APPEAL SUMMARY

Appeal ID: 21972	Project Address: 151 SW 1st Ave
Hearing Date: 10/9/19	Appellant Name: Luke Hendricks
Case No.: P-001	Appellant Phone: 5035420562
Appeal Type: Plumbing	Plans Examiner/Inspector: McKenzie James, Joe Blanco
Project Type: commercial	Stories: 5 Occupancy: B, M, S-1 Construction Type: III-A
Building/Business Name:	Fire Sprinklers: Yes - Fully Sprinklered
Appeal Involves: Reconsideration of appeal	LUR or Permit Application No.: 19-185198-CO
Plan Submitted Option: pdf [File 1] [File 2]	Proposed use: Office Building, Ground Floor Retail

APPEAL INFORMATION SHEET

P4.02

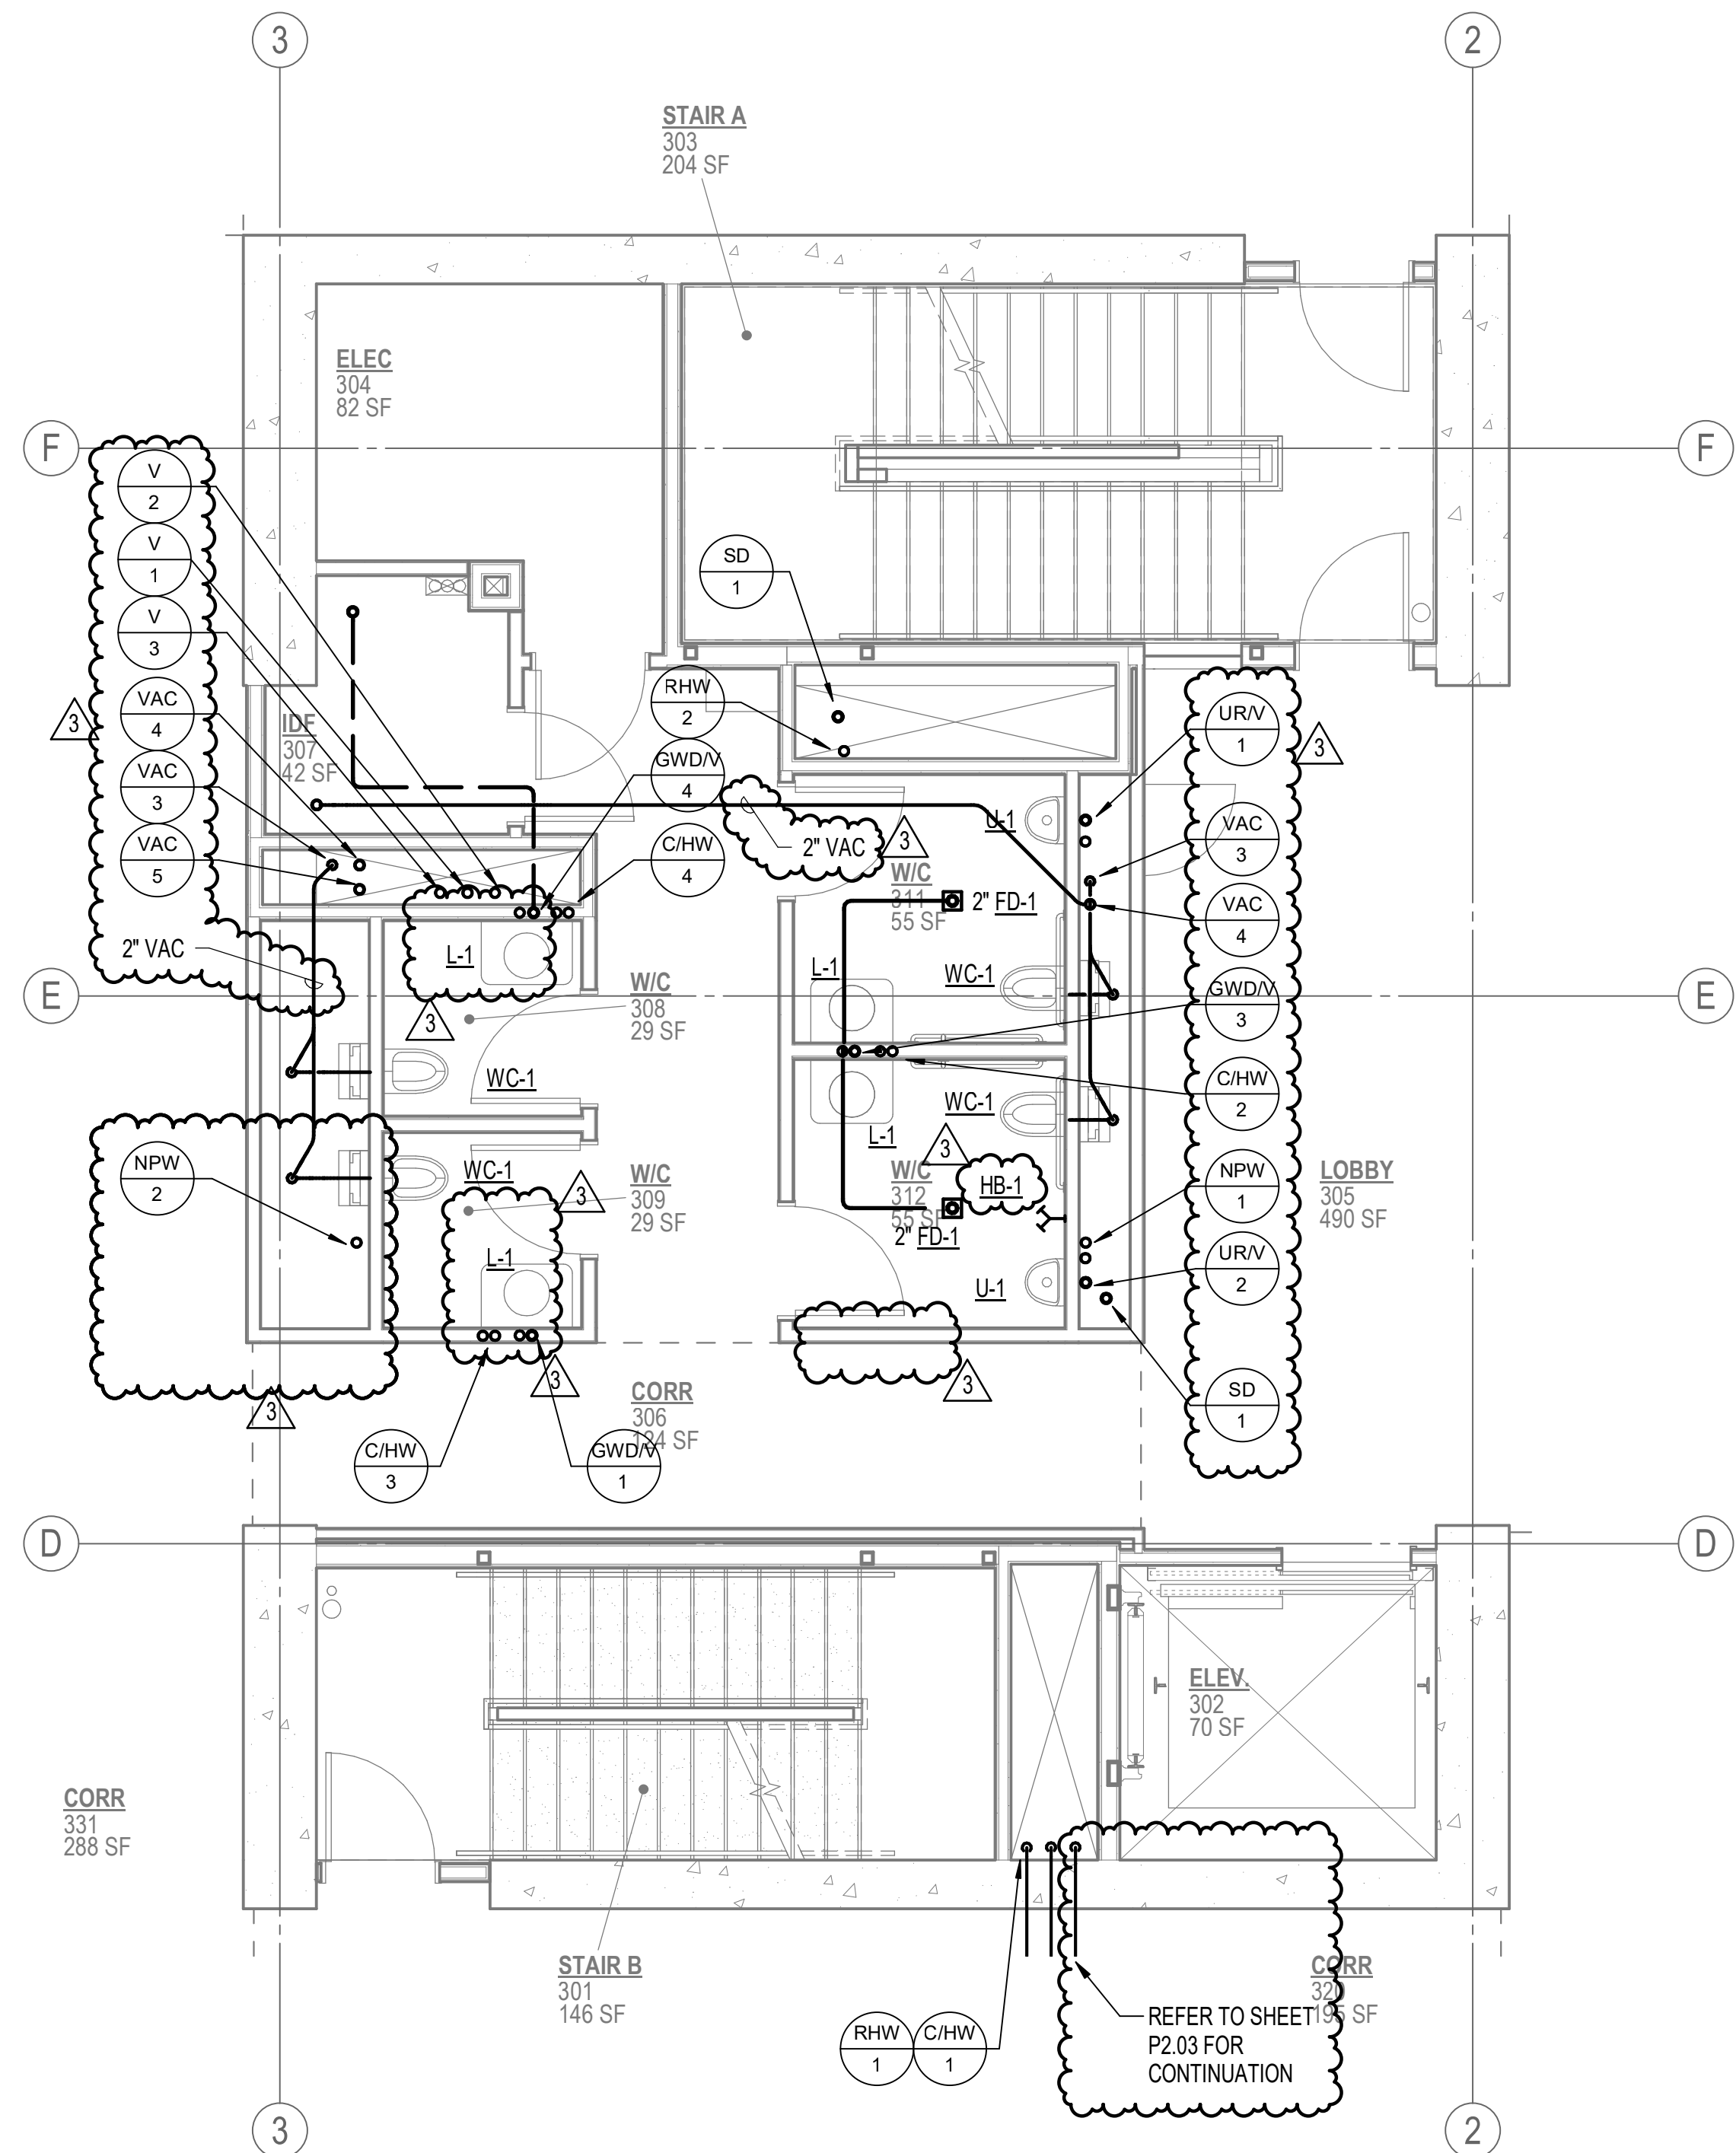
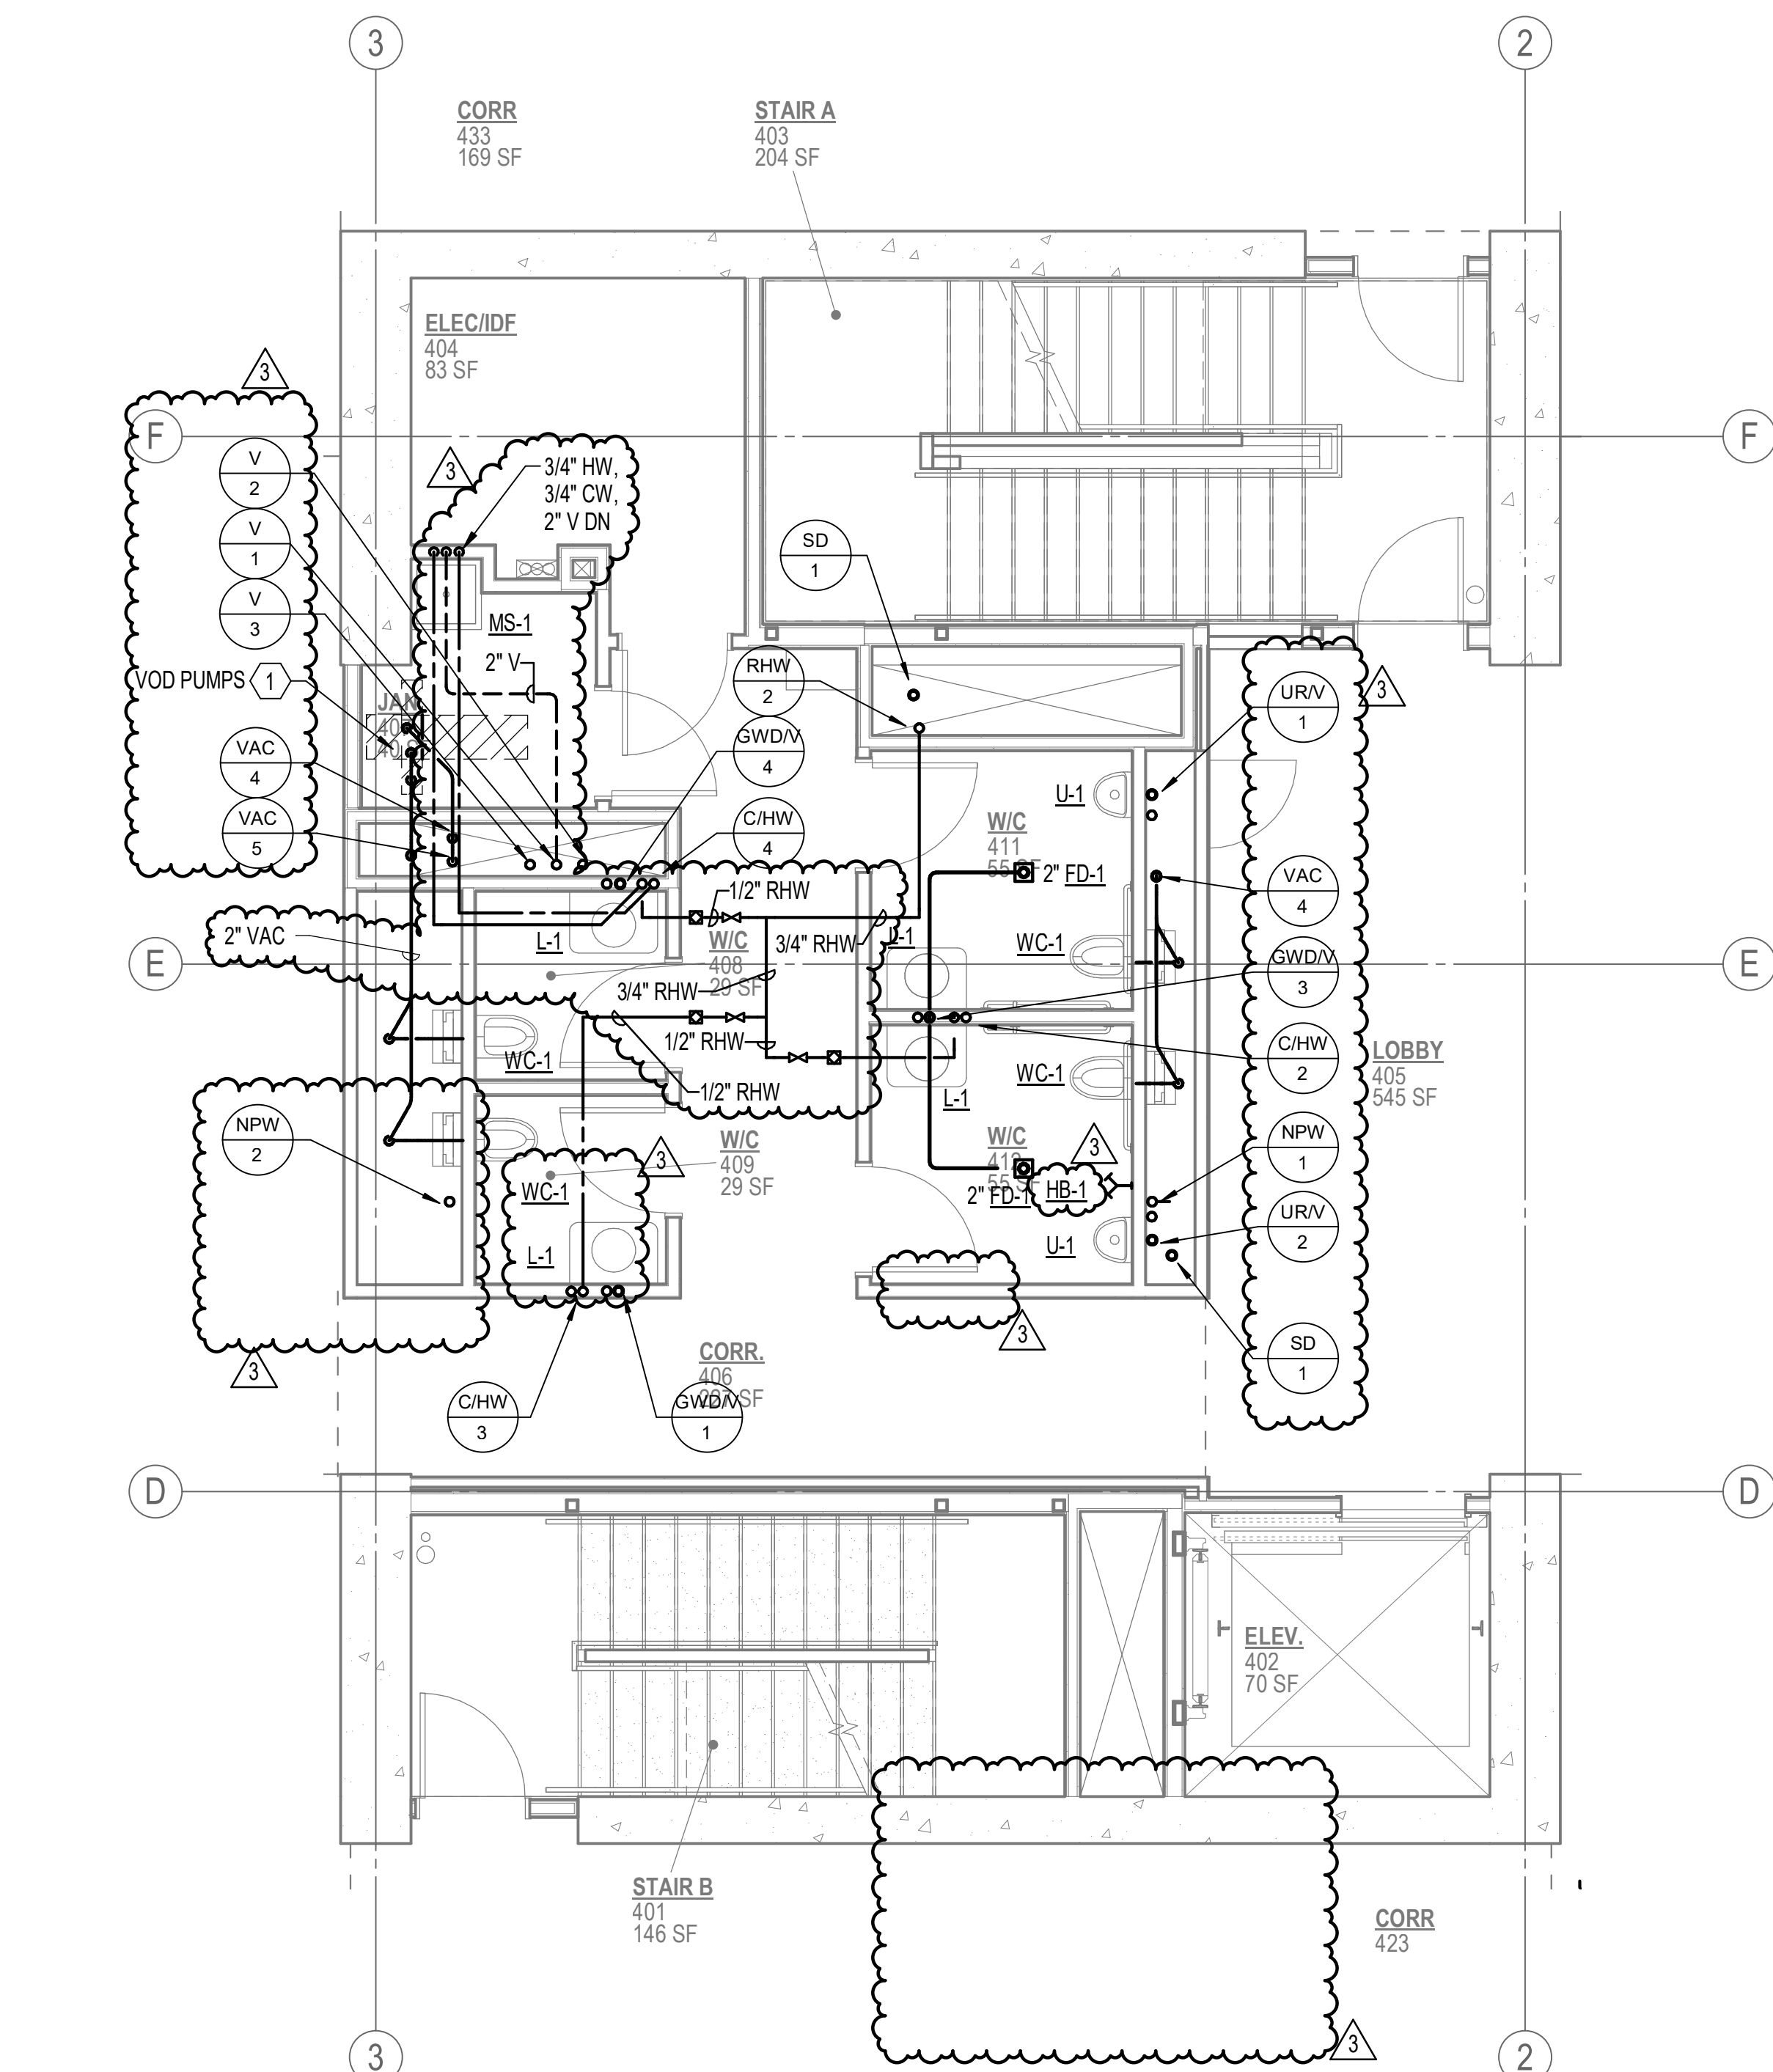
Proposed Design The building restroom core is comprised of four single occupant restrooms per floor on levels 2-5 and two single occupant restrooms on level 1. Each restroom is equipped with the following fixtures: low flow lavatory (0.35 GPM), a hybrid waterless urinal (1 gallon flushed every 72 hours via timer), and a low flow vacuum assisted water closet (0.12 GPF). A floor drain has been indicated in each restroom on the submitted drawings to meet the plumbing code.

Waterless urinals were initially provided in each single occupant restroom as a means to collect and divert as much urine as possible away from the composting system. The quantity of urinals initially proposed is above the building code minimum fixture quantity requirements based on occupancy load calculations. Additional urinals are beneficial to the operation of the composting system as it helps to reduce liquid in the system but is not a mandatory requirement. As a savings to the project, urinals will be removed from two of the restrooms on each floor. Removal of the urinals will also remove the plumbing code requirement to provide floor drains in those restrooms. This change will be implemented via a forthcoming addendum to the submitted drawings.

The proposed design is to remove the floor drains from the remaining single occupancy restrooms on levels 2-5 which is an exception to the plumbing code because they will be equipped with a lavatory, water closet, and waterless urinal. Floor drains will be provided in ground floor level 1 restrooms and mechanical room to provide low point drainage for the building.

Reason for alternative Under the current code, a single occupant, single flush fixture restroom does not require a floor drain. Waterless urinals are not technically a flush fixture. An exception to the code should be considered to not include the waterless urinal in the “two or more water closets or a combination of one water closet and one urinal” that triggers the requirement for a floor drain.

Due to the aggressive goals for water savings in this project, the proposed water closets and waterless urinals have a much lower flowrate than typical restroom flush fixtures. The proposed hybrid waterless urinals flush only 1 gallon every 3 days and proposed water closets flush only 0.12 Gallon per flush (GPF). This is over a 90 percent water reduction compared to low flow flush urinals (0.125-0.5 GPF) and water closets (1.28-1.6 GPF). The proposed plumbing fixtures only require a 1/2-inch water supply connection compared to 1-inch to 1-1/4-inch for standard flush fixtures. Additionally, the water connections are located within the fixtures where any leak or malfunction would send water into the fixture. A typical flush valve is exposed above the fixture with the potential to leak a higher quantity of water onto the floor. The code required floor drain is intended for emergency use due to the presence of multiple flush valves in commercial restrooms that are intended for more than a single user. The proposed fixtures have flow rates and water connection sizes similar to those found in a dwelling unit and therefore do not pose a high risk of flooding compared to a restroom with multiple exposed flush valves. In the event of a fixture overflow, the flow rates of fixtures are so low, that the volume of water would be minimal in comparison to a standard flush valve. Removal of the floor drain is proposed due to the lowered risk of flooding by the proposed fixtures.

A typical use for the floor drains in larger commercial restrooms is for cleaning or hosing down the floors. The proposed single use restrooms will be cleaned using a mop and bucket therefore the floor drain will not be needed for cleaning or sanitary purposes. For this reason, removal of the floor drain will provide equivalent health to the code required floor drain.

Trap primers are required for floor drains and utilize water to maintain the trap seal. An additional water savings can be achieved by removal of the code required floor drains and trap primers because water will not be required to maintain the seal in the floor drain traps. An energy savings can also be achieved by removal of the electronic trap priming manifolds which require an electrical connection for operation.

1. Omission of floor drains: **Denied. Proposal does not provide equivalent sanitary facilities.**
2. Use of the provisions of 2017 OPSC Appendix K for potable rainwater catchment system in a
